Advertising Concession at Eppley Airfield Request for Proposals

Addendum No. 2

November 4, 2025

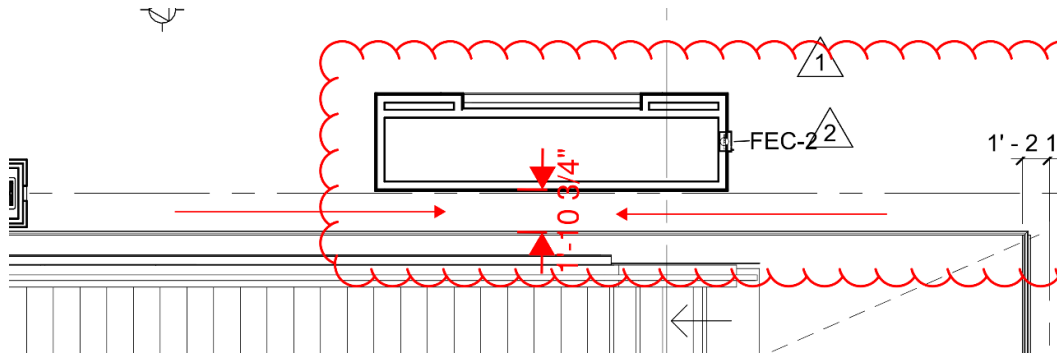
62. **RFP Section 4.1 – Advertising Program Description (pp. 4-1 to 4-4).**

Passenger Flow and Escalator Usage (PS-1, PS-2, and CP-2) Please provide the estimated percentage of arriving passengers anticipated to use each of the following escalators: PS-1, PS-2, and CP-2.

Response: This information is not available. Please refer to the response to Question 36 of this Addendum No. 2 for available information.
